Activity ID	Bid RFI's					
Subject:	RUHS Bid RFI Responses					
Date	2/25/2026					
AOR Name:	Leo Daly					
RFI #	Date Received	Contractor	Contractor RFI#	Comments	Author	Response
B001	2/19/2026	Bayview	#001	Please provide copy of hazardous materials survey report	RHUS	Report is Pending
B002	2/19/2026	Bayview	#002	Which trade package will be providing infectious control?	Bernards	<ul style="list-style-type: none"> Infectious control is required by each contractor Hard Temporary Barriers are provided by the Demo or Drywall Contractor
B003	2/19/2026	Bayview	#003	<ul style="list-style-type: none"> Are there any Union Requirements? Is there a PLA? 	Bernards	<ul style="list-style-type: none"> There are no Union Requirements There is no PLA, but this is Prevailing Wage
B004	2/24/2026	Level It Builders	#004	Can the design team please furnish an installation schedule for Cath Lab Rooms 1 & 2?	Bernards	Included in Bid Document

BUILDING TITLE
RIVERSIDE UNIVERSITY HEALTH SYSTEM MEDICAL CENTER

PROJECT TITLE
NEW CARDIAC CATHETERIZATION LAB SUITE & HYPERBARIC FACILITY EXPANSION

SHEET NUMBER
AE517

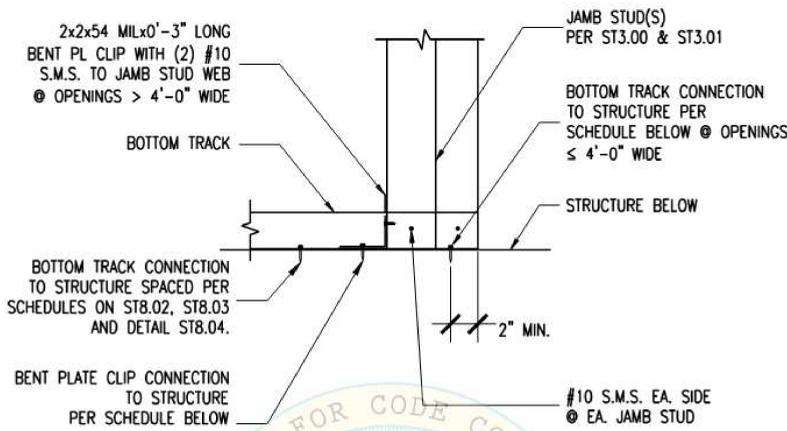
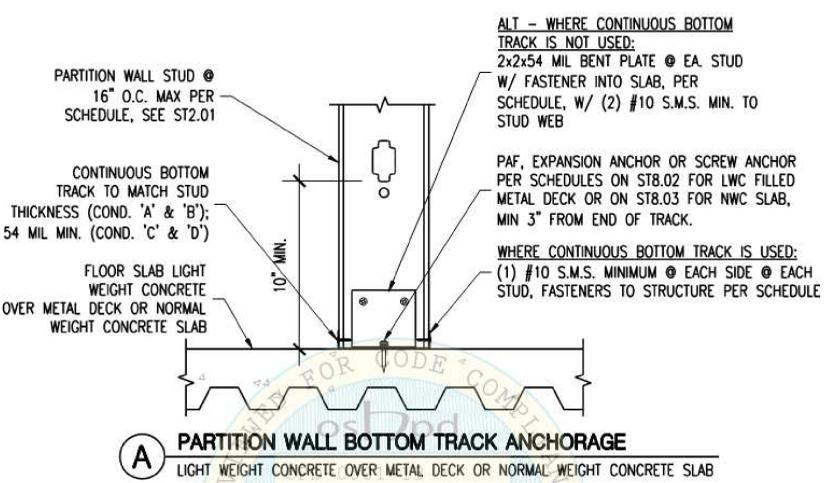
B028	2/24/2026	Brady West Inc	#027	Dets. A3, A5 & D5/AE515 & D1, D3 & D6/AE516 refer to Brace per schedule on ST6.01, however, this detail is not found. Please provide this detail	LAD	Detail ST6.01 is added to sheet AE517.
B029	2/24/2026	Brady West Inc	#028	Drawing AE121 shows Reception Room E1077 with no Ceiling, please confirm the Reception room E1077 DOES Receive a new ACT Clg?	LAD	Reception E1077 shall have a 2x2 grid ACT ceiling. Ceiling was turned off in error on the drawings.
B030	2/24/2026	Brady West Inc	#029	Please clarify wall heights at Walls S6L & S6A & S4A between Rooms E1047, E1047A, E1049A, E1049, E1049B & E1076 per Wall Types these extend to the structure (approx. 30' H. at this location), however, per sections on A1 & D1/AE301 these terminate at approx. 12' H. with the existing Vaulted ceiling to remain above. Provide bracing detail for these alls if they terminate at 12' and bracing is required.	LAD	Refer to response to B0028.

C2 STEEL BEAM STRENGTHENING
SCALE: 1 1/2" = 1'-0"

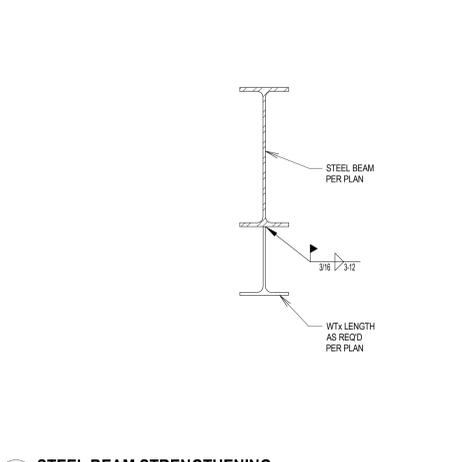
B011	2/24/2026	Brady West Inc	#011	Please confirm that the Fireproofing Scope in BP 09 - Insulation & Drywall Scope Item #4 is only for patching of existing fireproofing where new steel beams are connected to existing fireproofed beams and that the new steel beams added for unistrut support on C2 & C3/S211 DO NOT require any fireproofing as this steel is not part of the structural frame of the building. New Roof Steel will need access from the 2nd floor ceilings ?	LAD	Fire proofing is not required on new steel members supporting the unistrut framing system described in details C2 & C3/S211.
B013	2/24/2026	Brady West Inc	#012	What are the Lower Level Ceilings ? Will we need to patch any fireproofing above the lower level ceilings?	LAD	Contractor shall verify existing conditions on Lower Level for confirmation. As-built drawings provided by RUHS show the Lower Level to mostly be t-bar grid and lay-in tile.

B2 THRU BOLT STRUT DETAIL
SCALE: 1 1/2" = 1'-0"

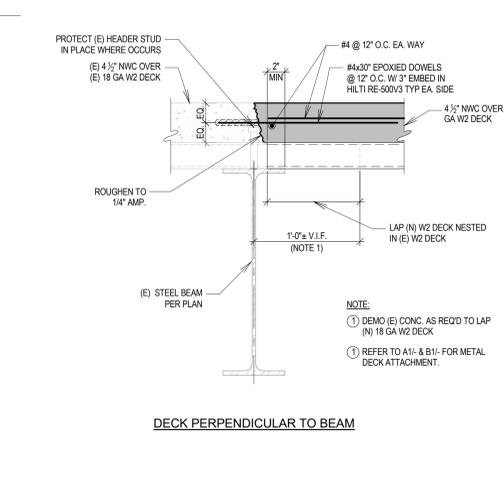
B005	2/24/2026	Level It Builders	#005	Atkore/Unistrut received an OPM to eliminate the additional weld on the sides of the channel and doesn't manufacture this anymore. Please find attached OPM. Can the design team please approve the use of P1001 instead?	ABS Engineers	P1001 members are approved for use on this project.
B006	2/24/2026	Brady West Inc	#006	AE611 shows Wall Type 1S6L at Control Room E1047A / Corridor E1048, however, the Lead Lined Walls Symbol is not shown on this wall. Please confirm this should be Wall Type 1S6 as no lead occurs at this location.	LAD	Confirmed. Lead lining only occurs where rooms E1047 and E1049 adjoin Corridor E1046 per shielding plan on AE141. No lead lining occurs where rooms E1047A and E1049A adjoin Corridor E1046.
B007	2/24/2026	Brady West Inc	#007	Several Walls are shown as non rated wall types (EX: S4A) however, have the 1 HR Rated Symbol on AE111, please confirm we are to use the symbols for determining where rated walls occur.	LAD	Where wall tags for rated and non-rated walls conflict with the wall hatch legend, the wall hatches shown on the plan shall govern as noted on AE111 for continuity of the required rating separation.
